# 1991 - 1992 Corvette: Service Bulletin: Starter Inoperative/Clicks/No Start

**Model and Year:** 1991-92 Corvette with Automatic Transmission

**Bulletin Number:** 92-322-6D

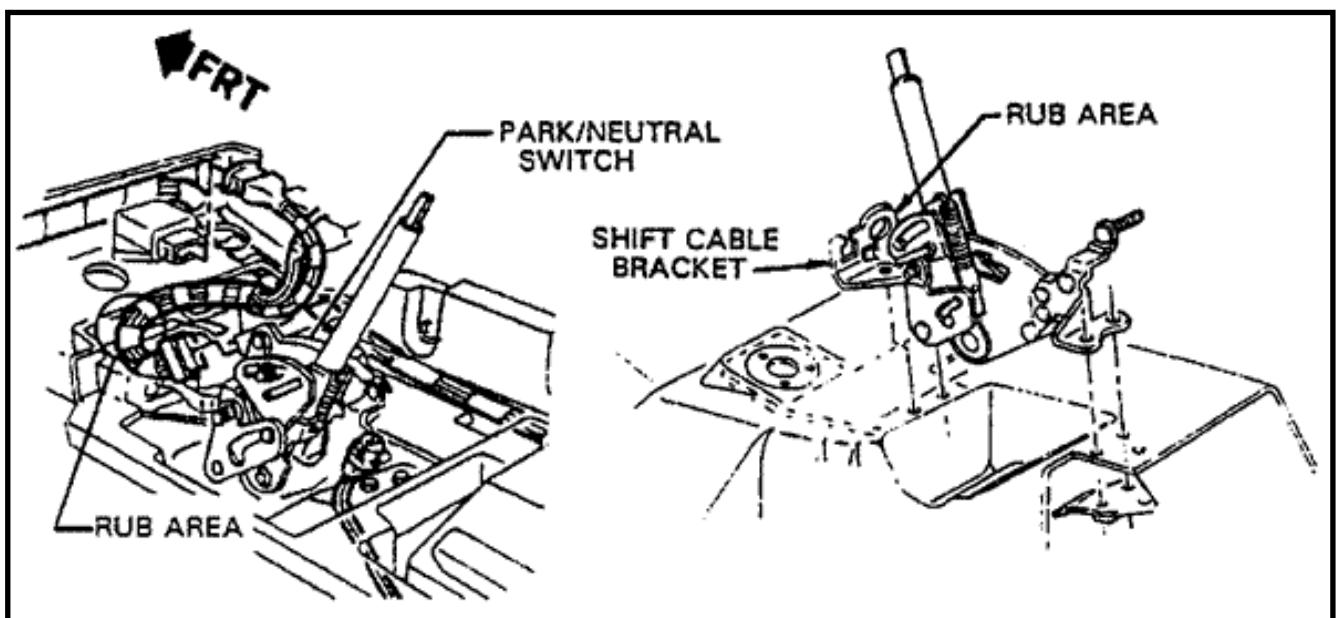
The 10 gauge purple wire from the park/neutral switch in the console is rubbing against the shift bracket (see illustration). This causes high resistance in the circuit, resulting in low voltage to the starter.

1. Disconnect negative battery cable.
2. Remove console trim plate as shown in the 1992 Y Car Service Manual, page 8C-11.
3. Check the wire harness in the area shown in the illustration for signs of rubbing. Correct as necessary.

4. Reroute the harness to the right of the bracket, about 50 mm (2 inches) over, and under the plastic portion of the console. Secure as needed to insure that the harness cannot contact the bracket
